Proposal for amendments to Regulation No. [xxx] (the Moving Off Information System for the Detection of Pedestrians and Cyclists)

The text was reproduced below was prepared by the experts from the VRU-Proxi Informal Working Group (VRU-Proxi) to amend the new UN Regulation on uniform provisions concerning the approval of motor vehicles with regard to the Moving Off Information System for the Detection of Pedestrians and Cyclists. The modifications to the existing text of the draft Regulation (see GRSG-118-06) are marked in bold for new or strikethrough for deleted characters.

Informal document No. GRSG-119-xx
(119th GRSG, 06-09 October 2020
agenda item xx)

Figure 1
Set Up for Static Crossing Tests

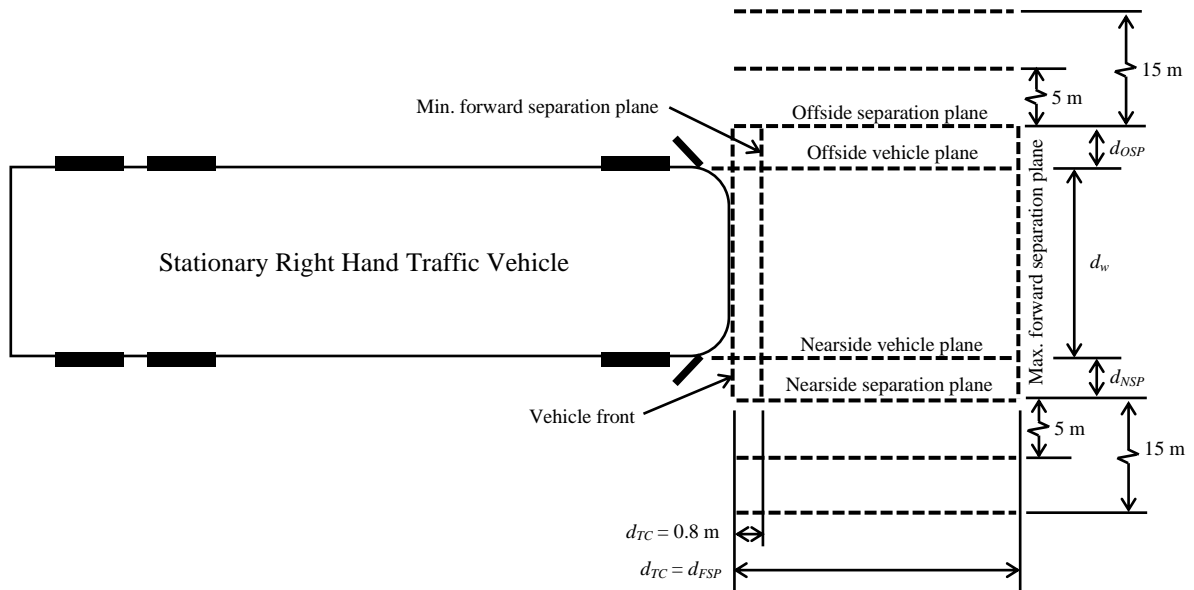
Appendix 1, amend to read:

- d_w vehicle width.
- ~~$d_{25\%}$ a distance relating to 25% of the vehicle width.~~
- d_{NSP} the distance from the nearside vehicle plane to the nearside separation plane, defined as 0.5 m.
- d_{OSP} the distance from the offside vehicle plane to the offside separation plane, defined as 0.5 m.
- d_{TC} the forward separation distance for each test case.
- d_{FSP} the distance from the vehicle front to the maximum forward separation plane.
- ~~d_{LPI} the distance relating to the last point of information (LPI).~~

1. Justifications for paragraph 5.2.2.3.3.: MOIS focuses on straight driving situations. As the testing procedure is not defined, this part of the requirement may lead to too many testings.
2. Justifications for paragraphs 5.4.2 to 5.4.4: Paragraph numbers modified as 5.4.2. was used twice.
3. Justifications for paragraph 5.5.1.: In VRU-Proxi#14, we agreed to use the word initialisation instead of calibration to be in line with the wording used in the AEB regulation. The MOIS (and the AEB) needs driving situations to initialise the system.
4. Justifications for paragraph 5.7.4: As the testing procedure is not defined, this part of the requirement may lead to too many testings.
5. Justifications for paragraph 5.8.3.: 5.8 deals with failure warning signals.
6. Justifications for Appendix 1.: clarifications of the definitions listed for the table 1 and figure 1.
